VIRGINIA ELECTRIC AND POWER COMPANY
RICHMOND, VIRGINIA 23261

August 27, 2014

Serial No.: 14-424
NAPS/RAP: R0
Docket Nos.: 50-338/339
License Nos.: NPF-4/7

VIRGINIA ELECTRIC AND POWER COMPANY
NORTH ANNA POWER STATION UNITS 1 AND 2
PROPOSED LICENSE AMENDMENT REQUEST
CLARIFICATION OF REACTOR COOLANT SYSTEM
HEATUP AND COOLDOWN TECHNICAL SPECIFICATION FIGURES

Figure 3.4.3-1 (page 1 of 1)
North Anna Units 1 and 2 Reactor Coolant System Heatup Limitations
(Heatup Rates up to 60°F/hr),
Applicable for the first 50.3 EFPY for Unit 1, and 52.3 EFPY for Unit 2
(Including Margins for Instrumentation Errors)

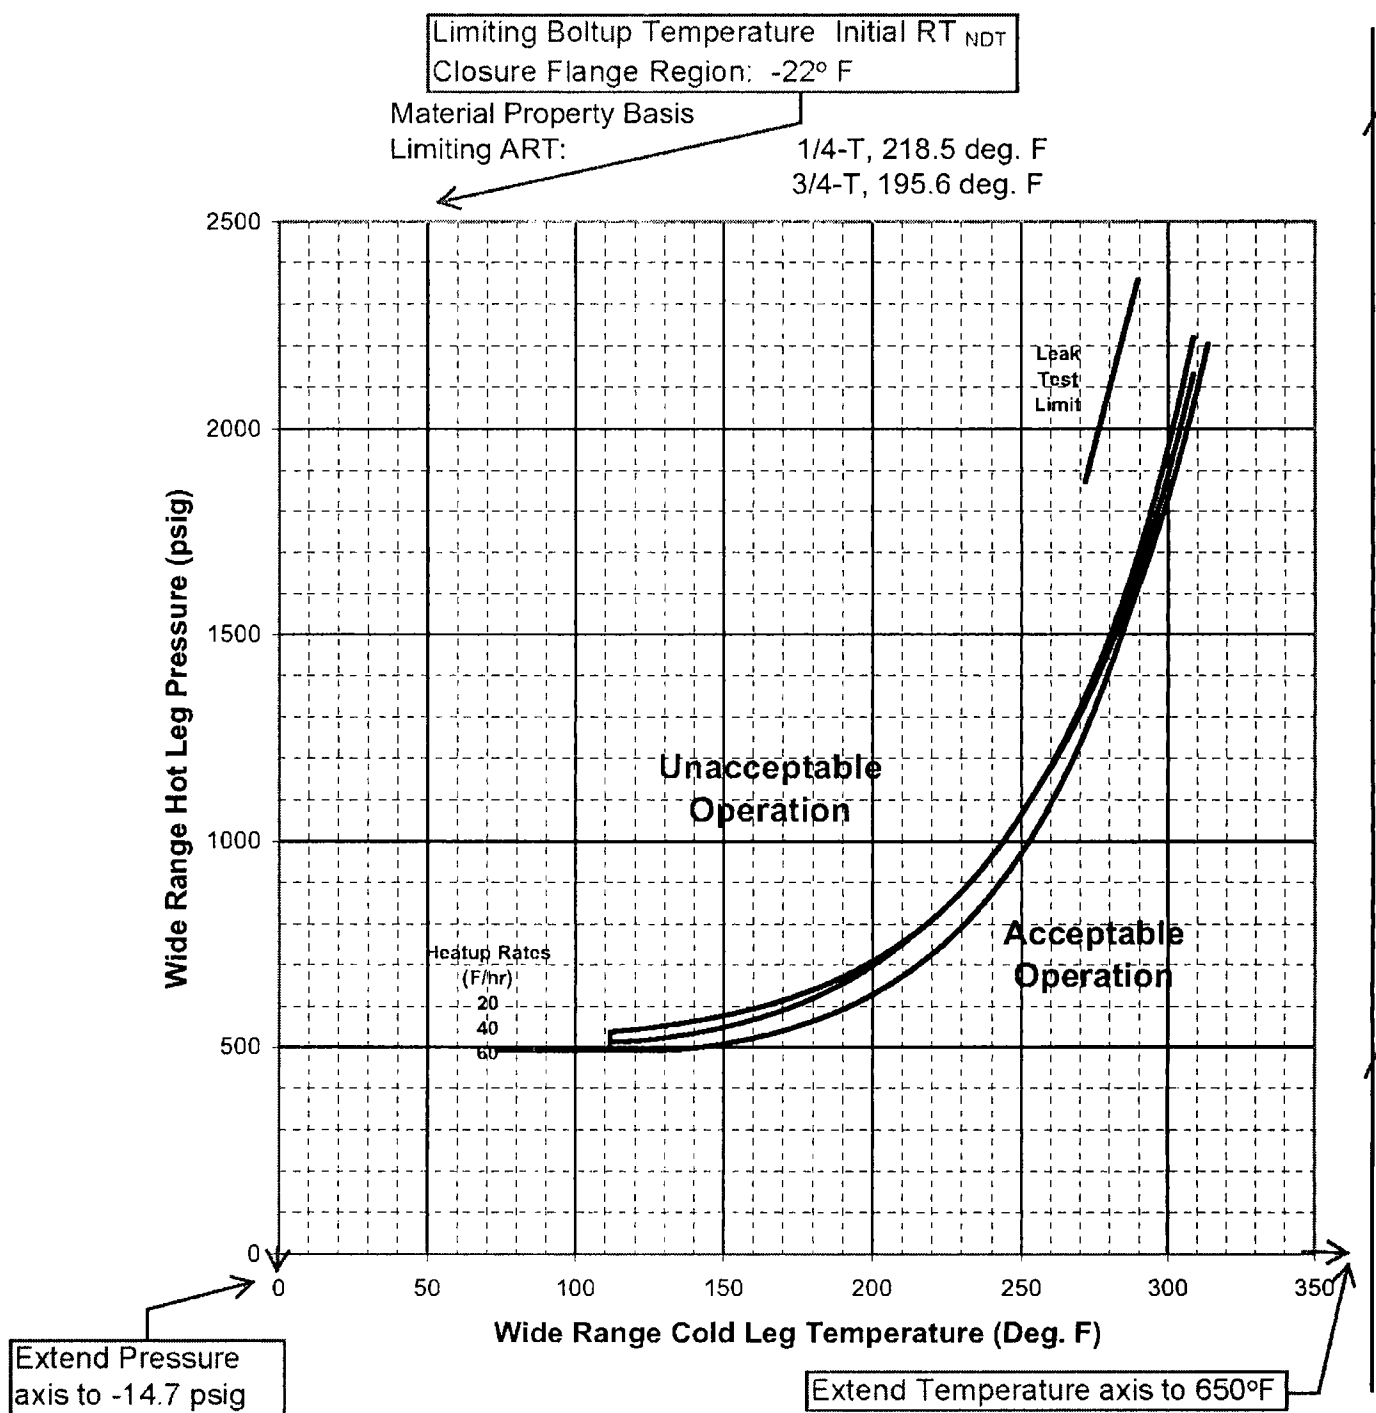
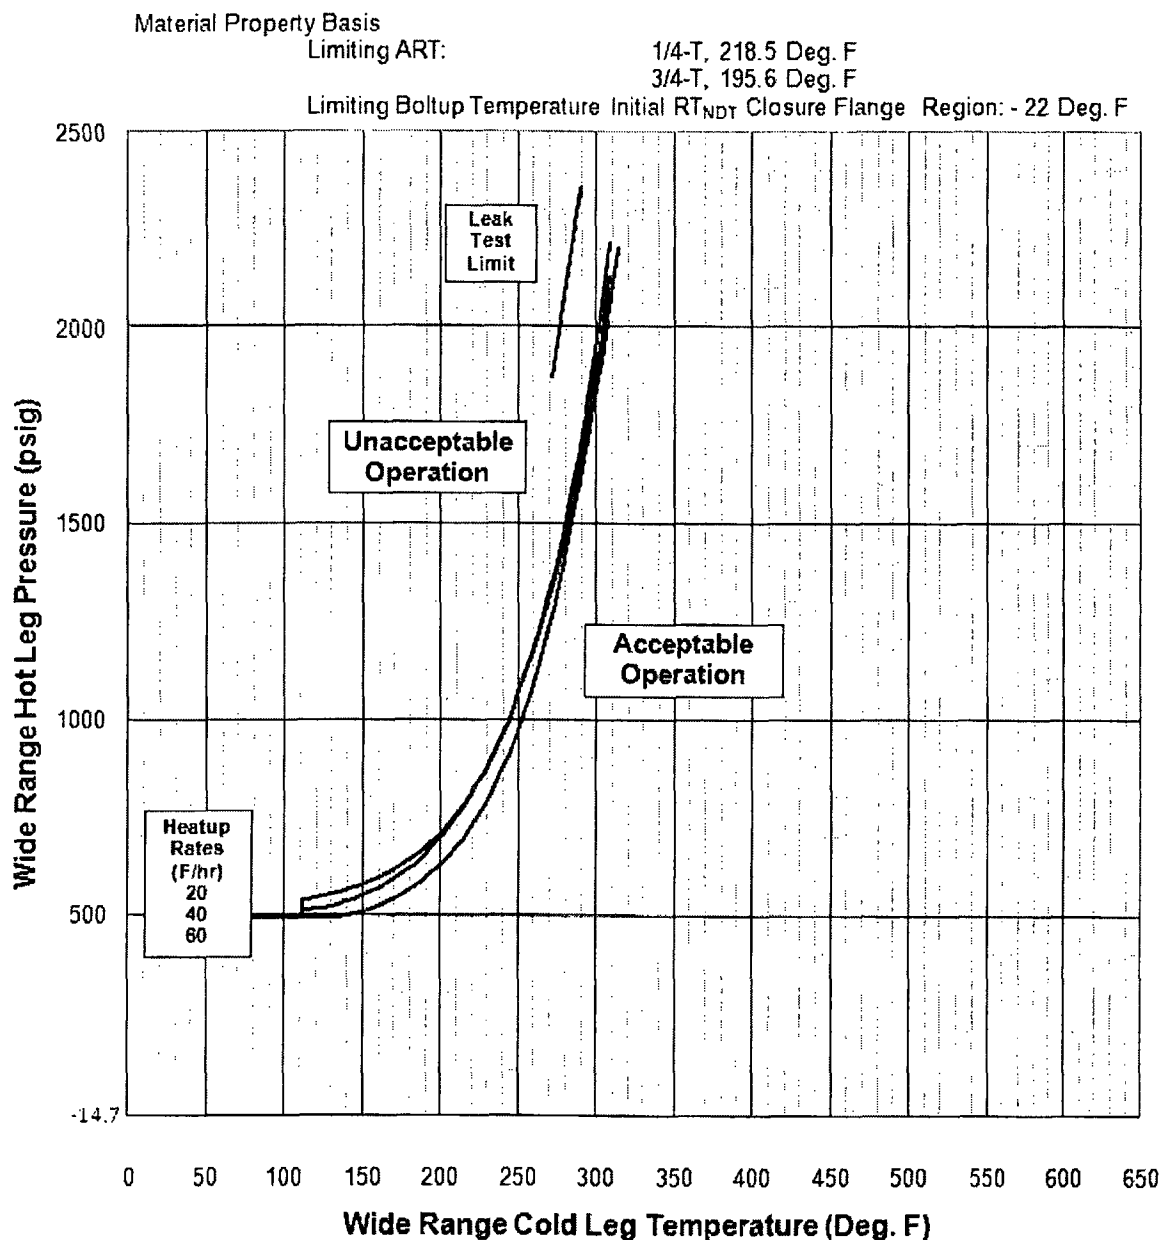
- TS Figures 3.4.3-1 and 3.4.3-2 are revised for clarification as follows:
 - The temperature axes are extended from 350°F to 650°F, which corresponds to the reactor vessel design temperature and bounds temperatures up to RCS full power operation.

- The pressure axes are extended from 0 psig to -14.70 psig to bound RCS conditions to support vacuum-assist fill of the RCS loops, which is a loop fill option addressed in the North Anna RCS fill operating procedures.

- The phrase, "Limiting Boltup Temperature North Anna Initial RT_{NDT} Closure Flange Region: -22°F," is added, since the figures do not currently address boltup temperature.

The extension of the temperature axes from 350°F to 650°F on Figures 3.4.3-1 and 3.4.3-2 is appropriate since the region of Acceptable Operation includes a maximum temperature corresponding to the reactor vessel design temperature of 650°F, which bounds temperatures up to RCS full power operation.

With the extension of the pressure axes from 0 psig to -14.70 psig, the region of Acceptable Operation includes a pressure range from -14.70 psig up to the maximum pressure set by the existing limit curves. The extension of the pressure axes to -14.70 psig on Figures 3.4.3-1 and 3.4.3-2 is appropriate to bound RCS conditions to support vacuum-assist fill of the RCS loops. The extension of the pressure axes is also appropriate since vacuum-assist fill of the RCS loops is an RCS loop fill option addressed in the North Anna RCS fill operating procedures. Vacuum-assist fill of the RCS loops in Modes 5 and 6 is an acceptable condition since the resulting pressure and temperature combination is located in the Acceptable Operation region of Figures 3.4.3-1 and 3.4.3-2. An engineering evaluation was performed by Dominion that demonstrates the RCS loop piping and steam generator tubing will maintain their structural integrity with considerable margin when subjected to vacuum conditions during vacuum-assist loop fill.
